Town of Surfside

Town Stormwater Improvements

Abbott Avenue Pump Station Project

Addendum No. 5

SHEET NUMBER: CP-502 PROJECT NUMBER: 11494.01

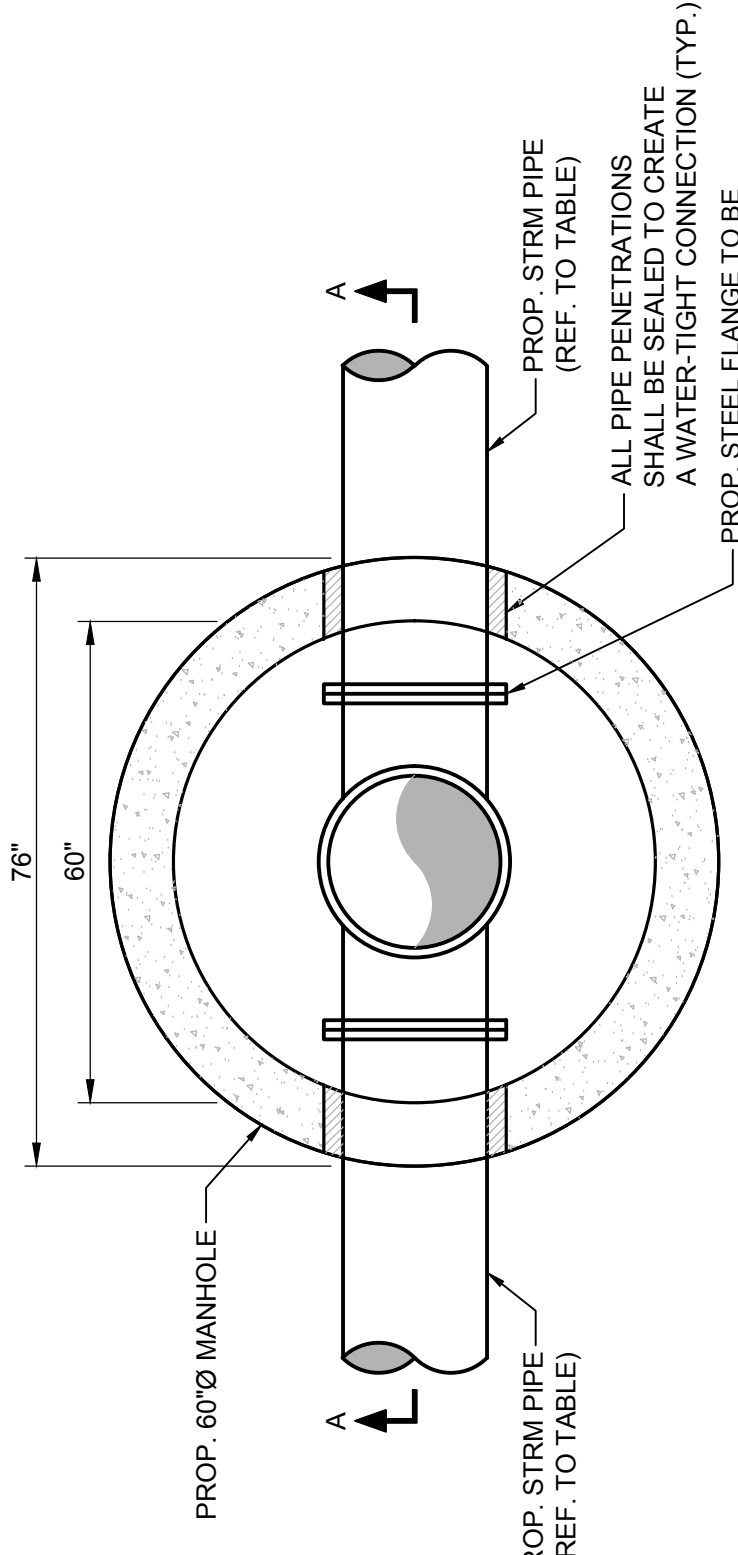
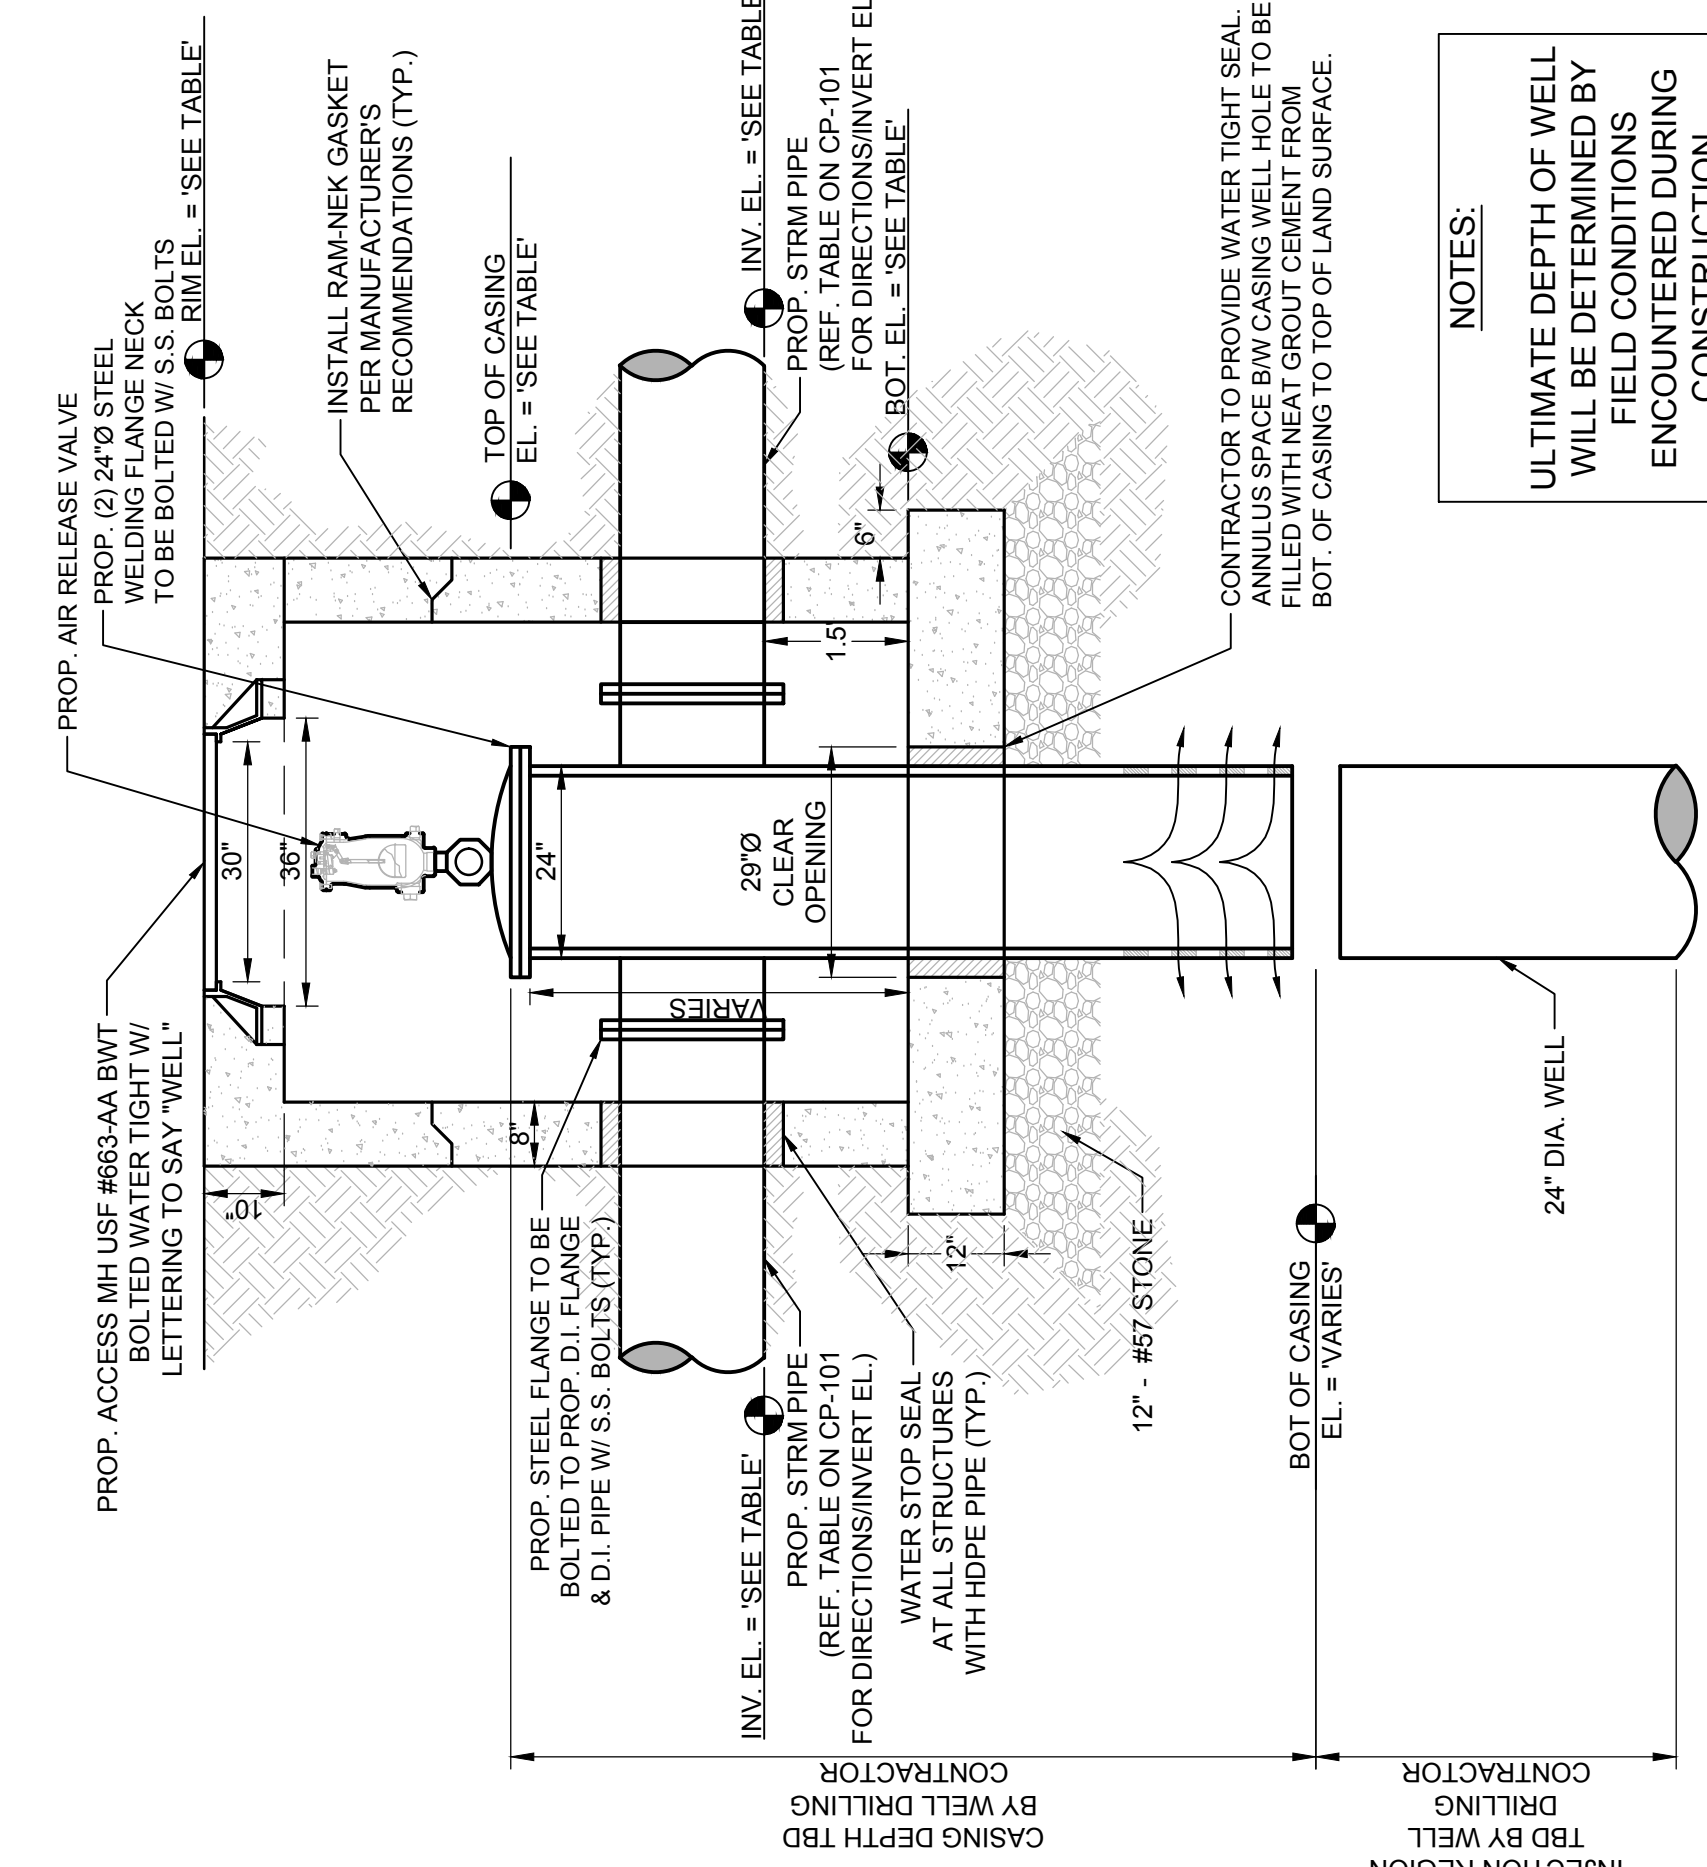
- 1. Bid submission deadline is extended until Monday, December 11th, 2023, at 2:00 P.M.**
2. During the pre-bid conference meeting, a question arose about the size of the manholes and the tee inside of them.

Response: The plans have been revised to accurately depict the appropriate manhole size. Refer to Sheet CP-502.
3. At the pre-bid conference meeting, there was a question about the asphalt mix design specifications.
